**UPDATE!** **RECALL 17V-379: CHECK AND REPLACE LEFT REAR LAMP**

This Service Information bulletin supersedes SI **B63 08 17 dated June 2017**

F01 (7 Series)	F02 (7 Series)
----------------	----------------

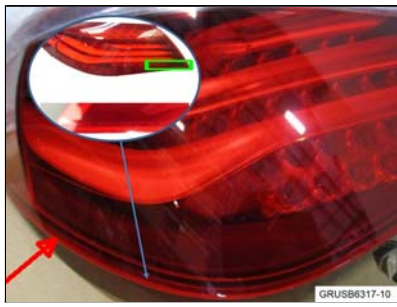
Check the left rear light in the side panel and replace it if it is missing the reflector (wrong part in the vehicle).

<p>Check left rear light in the side panel. Is the rear reflector and the Society of Automotive Engineers identification present as shown in picture? YES: No further repair is required. The Recall is completed.</p>
	<p>No: If they are not present (as shown in picture), then follow next step: Follow ISTA REP 63 21 180 “Removing and installing/replacing left or right rear light (in side panel)”. Replace the left rear light to complete the recall.</p>

Part Number	Description	Quantity
63 21 7 300 269	Rear light, left	1
